Change Order Request

PFAS Well 15

Field Order 11- Curb at Generator Area

FO#11

10-S-01

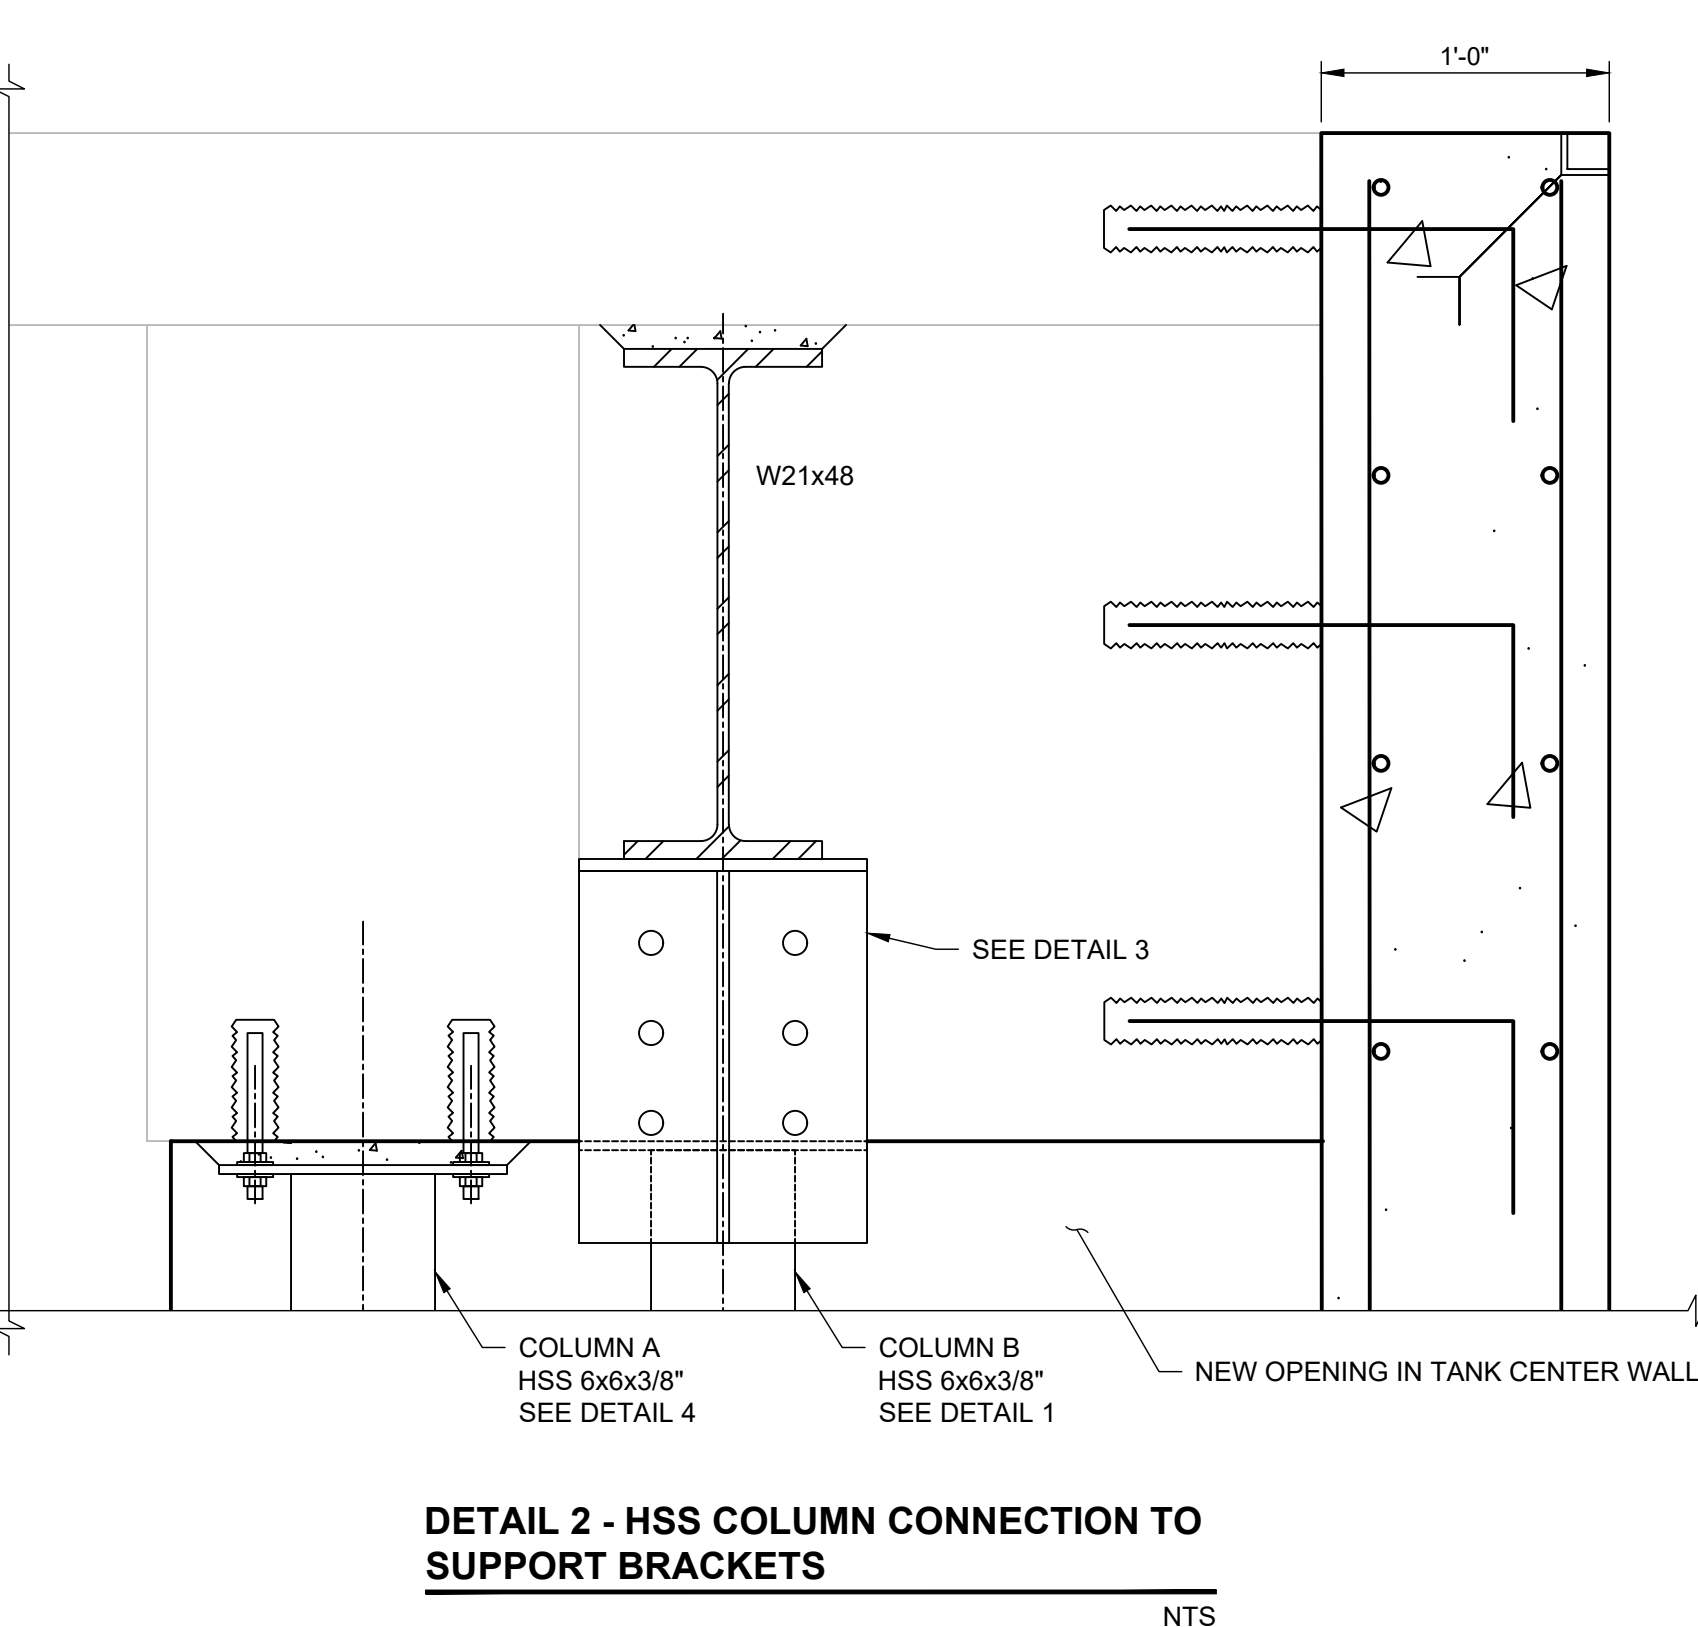
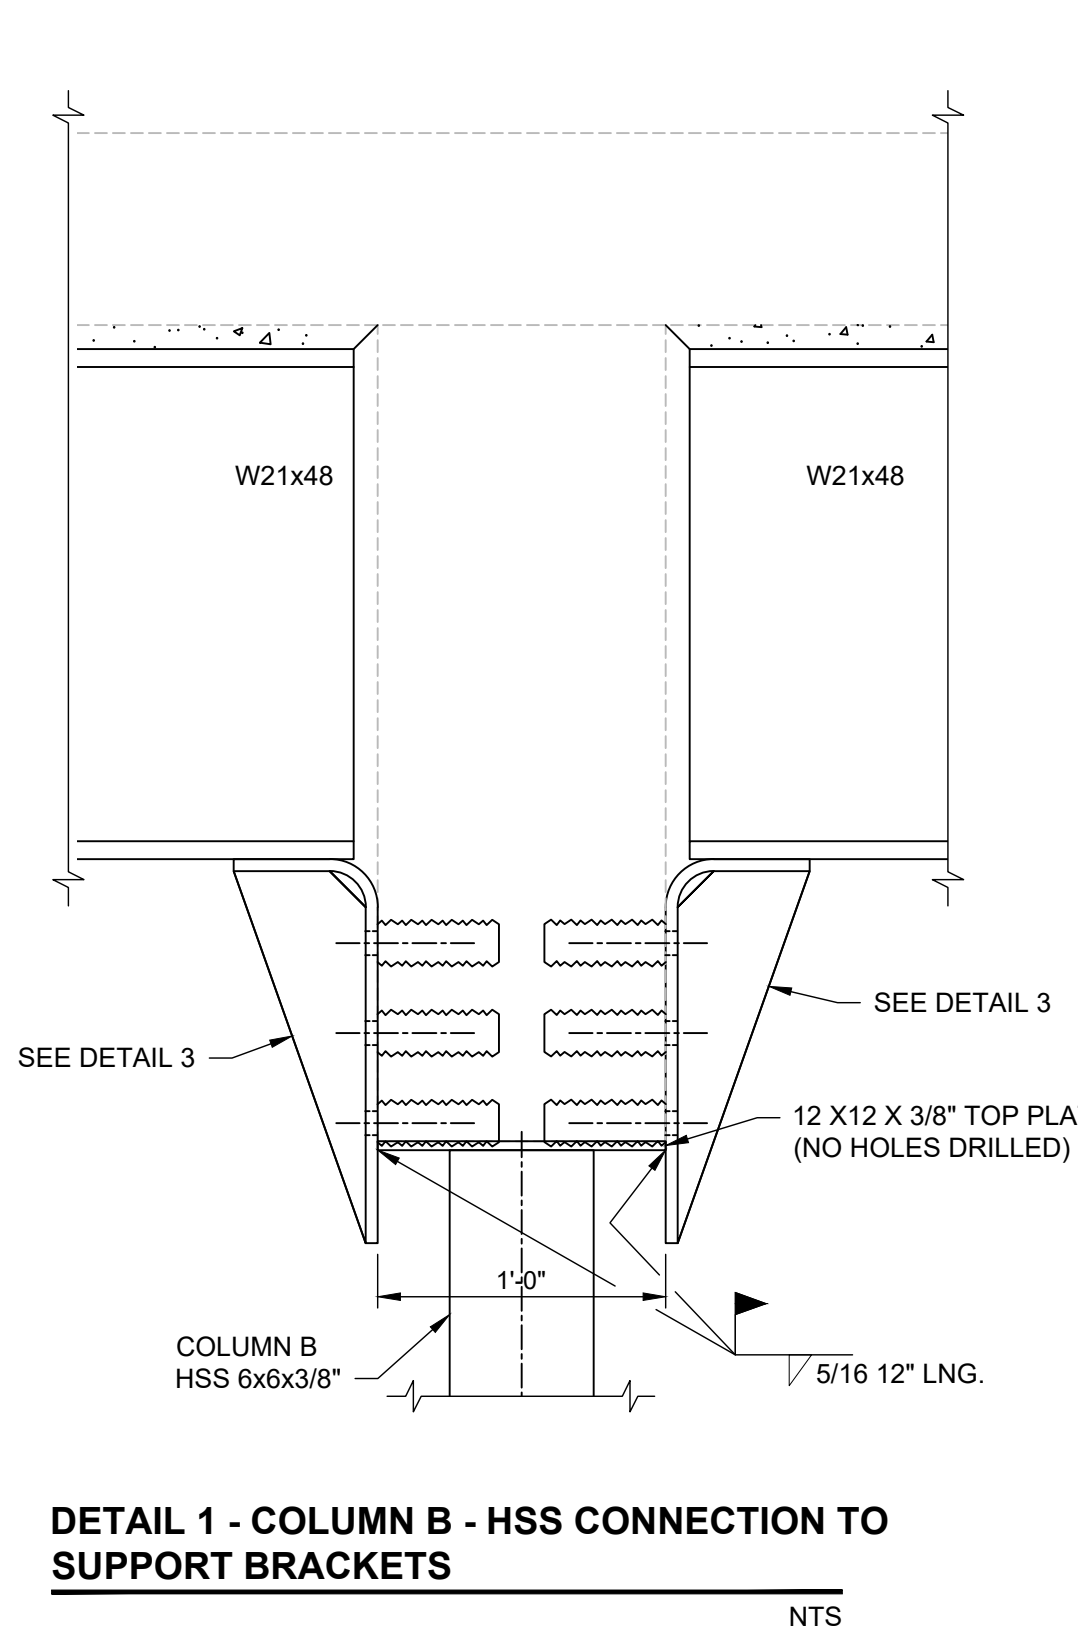
ISSUE/REVISION		
1	10/21/2024	RESPONSE TO RFI #35
I/R	DATE	DESCRIPTION

1. The existing 5 to 6-inch deep sawcuts at the two locations are to be cleaned out and filled with epoxy by gravity feed with resin method in accordance with the manufacturer's recommended installation procedures.
 - a. Reference: American Concrete Institute's' ACI RAP Bulletin 2 – Field Guide to Concrete Repair Application Procedures, Crack Repair by Gravity Feed with Resin.
 - b. Epoxy material shall be Sikadur-32 Hi-Mod manufactured by Sika Corporation or engineer's approved equivalent.
2. Install steel columns as shown on the attached revised drawing Nos. 10-S-01 and 10-S-08, dated 10/21/24 and Sketch SK-4 dated 10/21/2024 to support existing slab and beam floor system. SK-4 will be incorporated into the As-Built drawings when project is completed.
3. Provide cost and schedule impacts, if any, for this work to AECOM and Owner for review prior to commencement of work.

SK-3 STUB WALL DETAIL

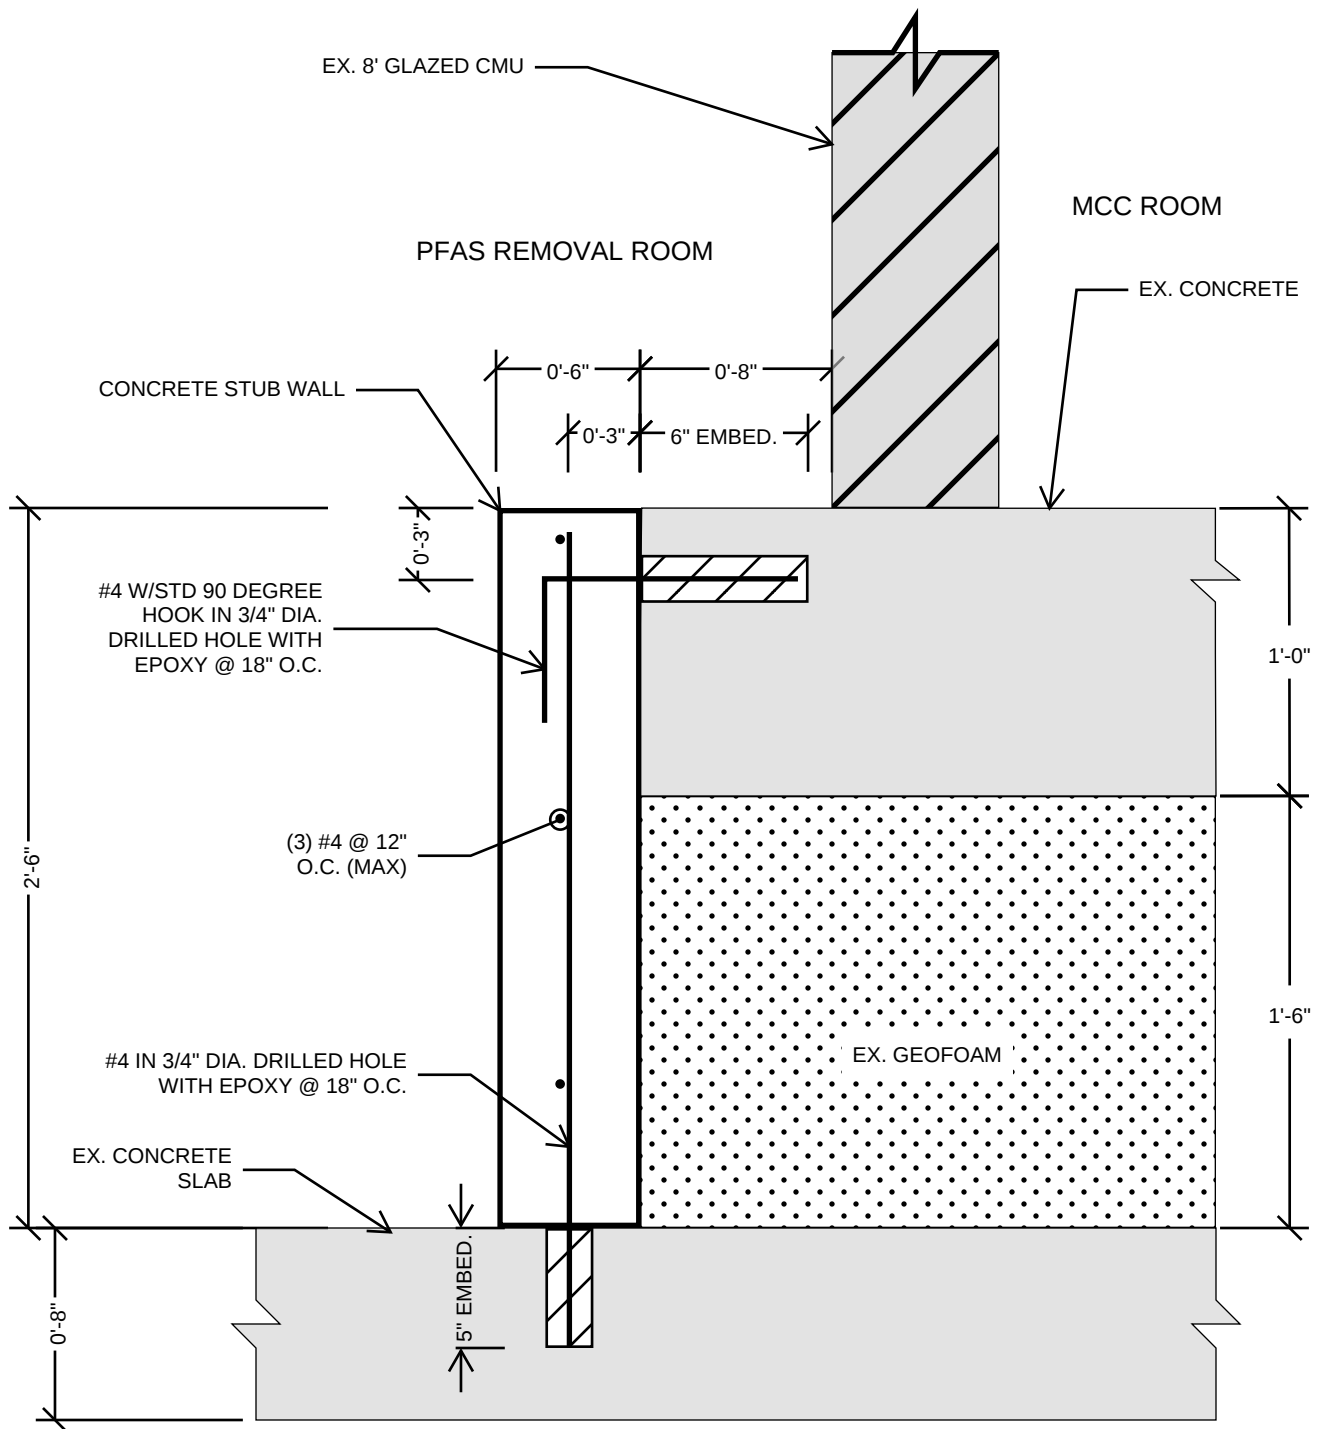
6" wall under east floor at cut, plans show existing to remain. After demo it was discovered there is no existing wall here. We would propose CMU infill under the existing slab as there is not enough room to build a wall out past where the floor is cut without impeding on filter vessel footprint.

1. INFILL VOID BETWEEN EXISTING CONCRETE AND GEOFOAM WITH CONCRETE WHEN PLACING STUB WALL.
2. CONTRACTOR TO FIELD VERIFY ALL DIMENSIONS.
3. COORDINATE WITH OTHER TRADES FOR PENETRATIONS THROUGH STUB WALL PRIOR TO PLACEMENT OF CONCRETE.

PROJECT NUMBER
60686092
SHEET TITLE
P&ID DIAGRAM - TANK RESERVOIR
AND BWW/FTW TANKS
DWG NUMBER SHT NUMBER
09-N-03 20 OF 55

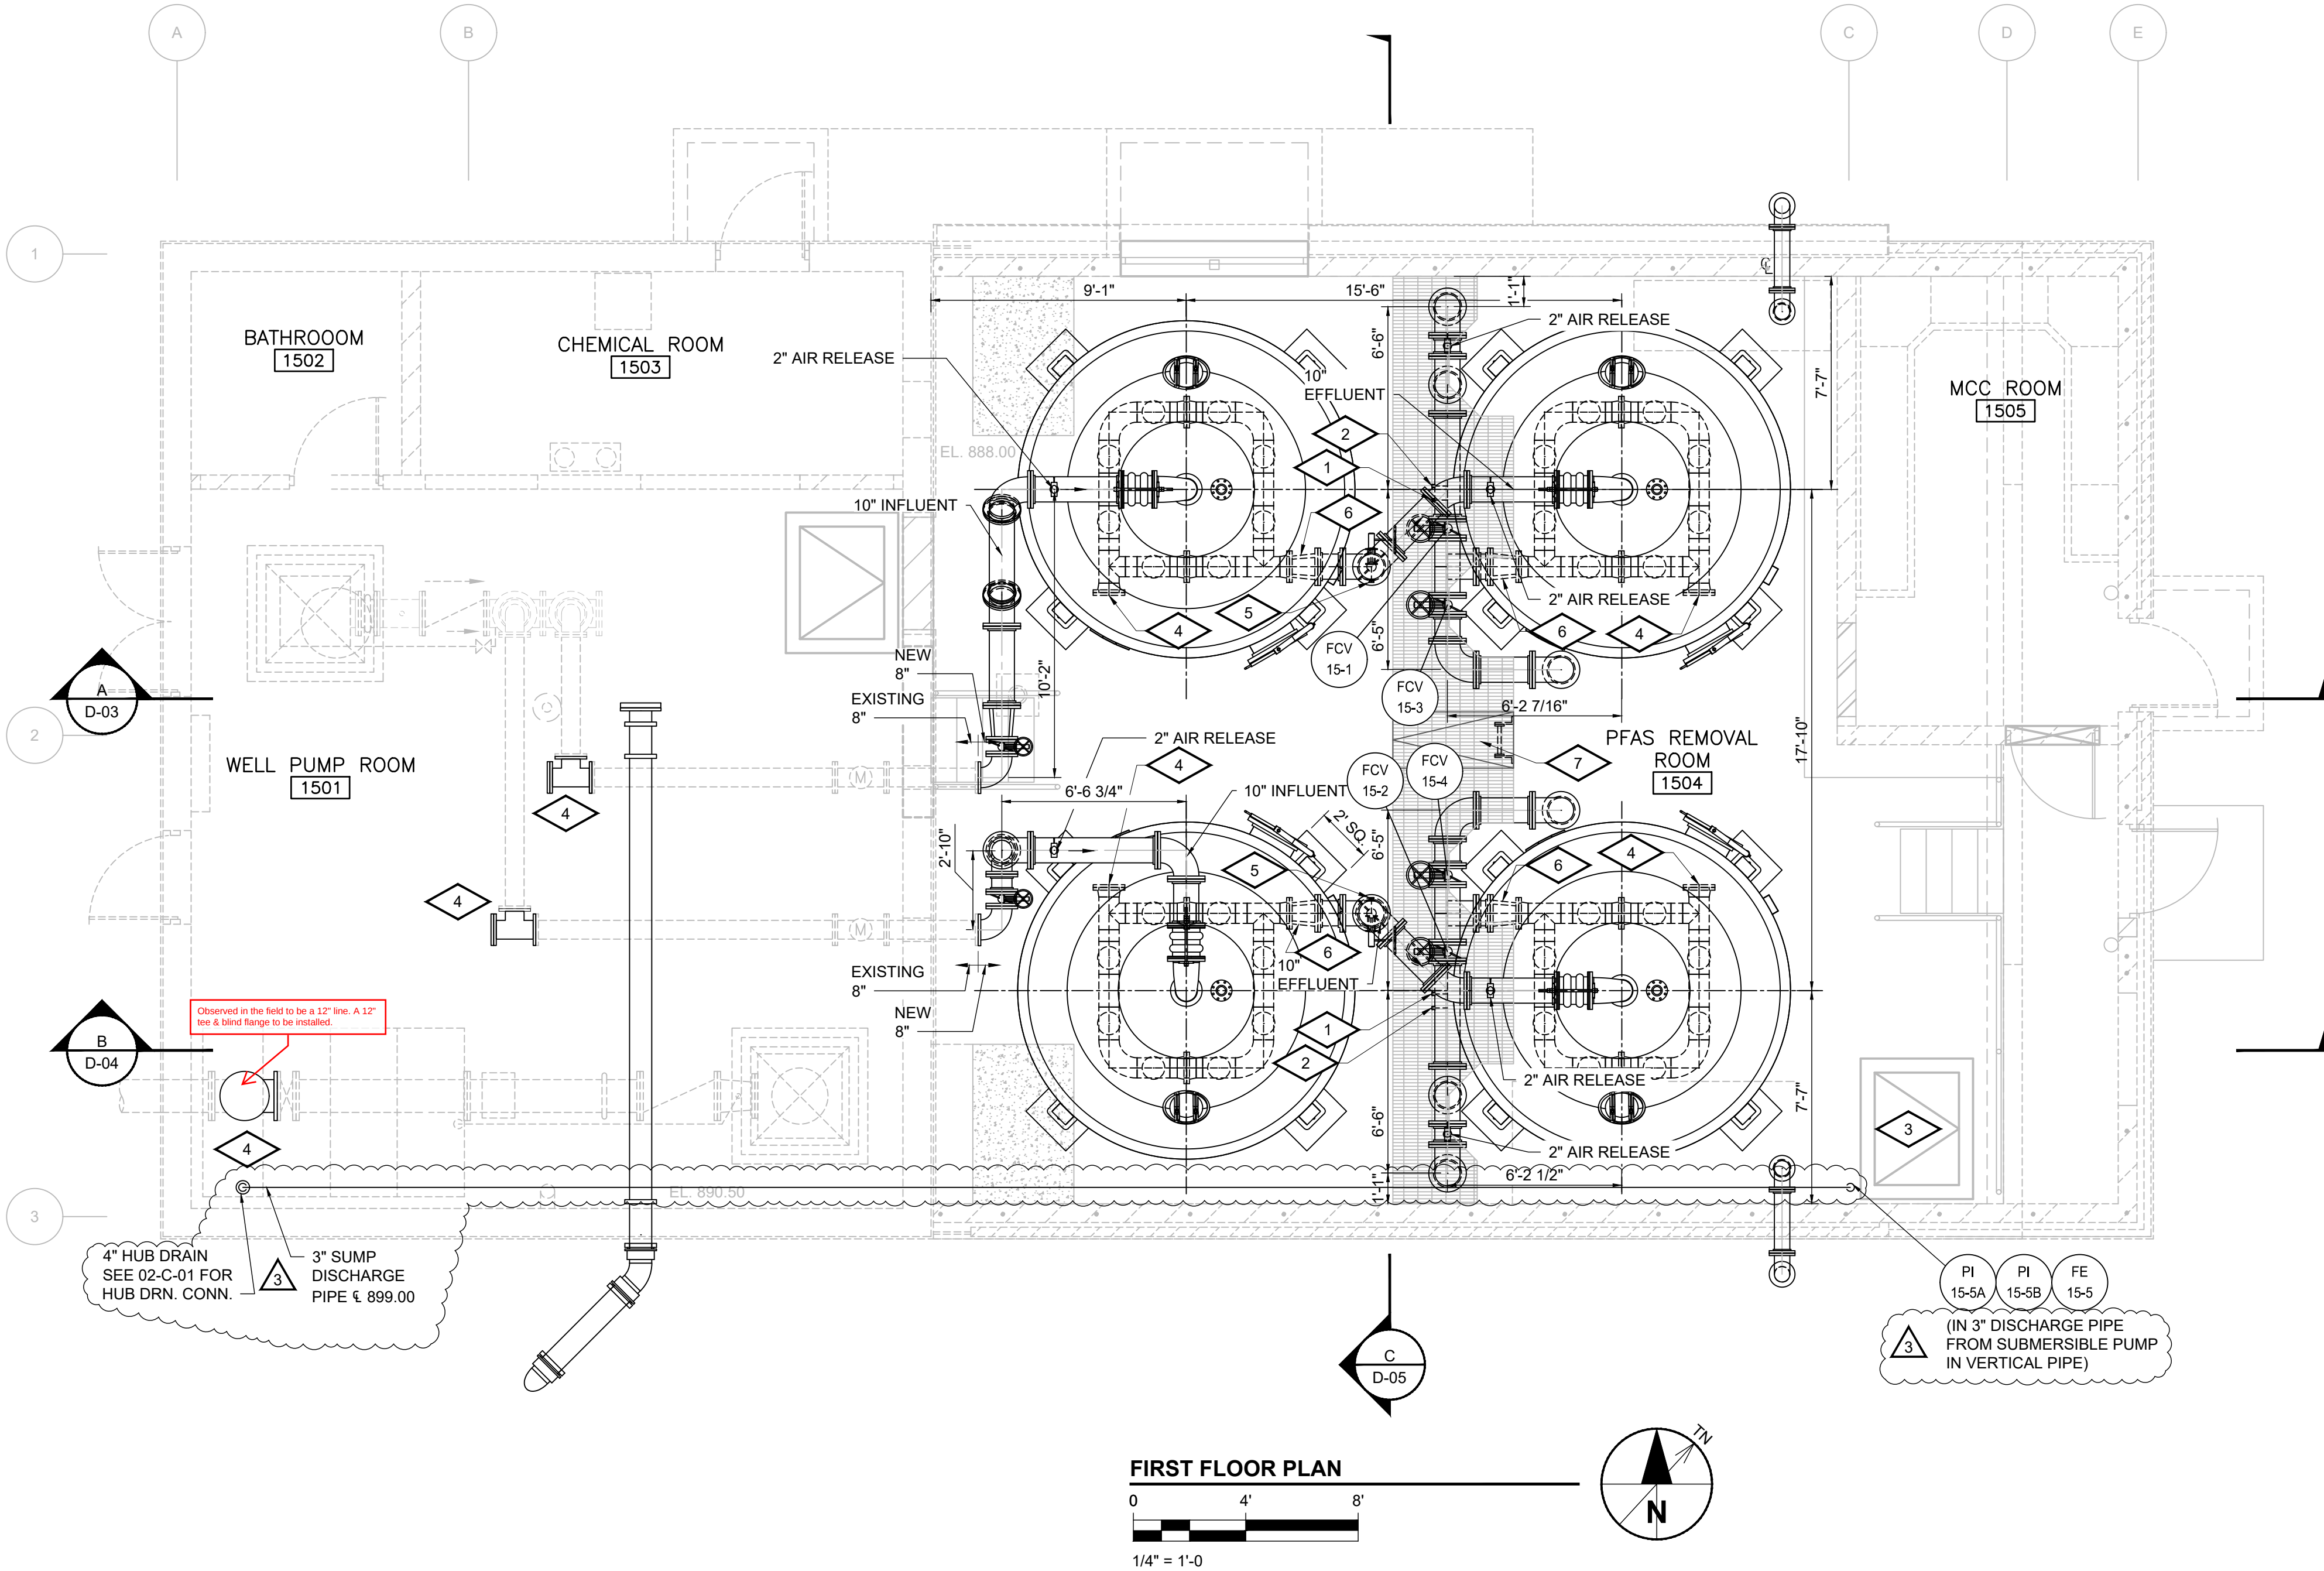
This change order is for the labor, material & equipment to provide one (1) 12" ductile iron tee & one (1) 12" ductile iron blind flange. Sheet(s) 09-N-01 & 09-N-03 note this line to be a 14" size. During install it was observed that the line was 12". New materials were required to match the correct line size. The materials already ordered cannot be sent back to the supplier for a credit. During the installation it was noted that there was blockage at the 12" butterfly valve. The downstream spool was removed to further inspect the debris within the pipe. The debris was removed and the spool was reinstalled with gaskets supplied by MWU. Once the line was commissioned it was observed that the spool was leaking. The contractor provided new gaskets at the spool to stop the leaks and replace the gaskets supplied by MWU.

- 1 CHEMICAL INJECTION POINT
- 2 CHEMICAL INJECTION POINT
- 3 3-INCH LINE FROM SUMP PUMP CAM-LOCK CONNECTION TO HUB DRAIN IN PIPE PIT AT HIGH SERVICE PUMP DISCHARGE. WALL PENETRATION PER DETAILS.
- 4 REPLACE ELBOW WITH TEE AND ADD BLIND FLANGE FOR START UP AND MEDIA REPLACEMENT.
- 5 1" WELDED TAP AND BALL VALVE.
- 6 8"x10" EXPANSION JOINT REDUCER.
- 7 REMOVABLE GRATING FOR ACCESS TO BELOW AND PUMPING OUT THE OVERFLOW CHANNEL.
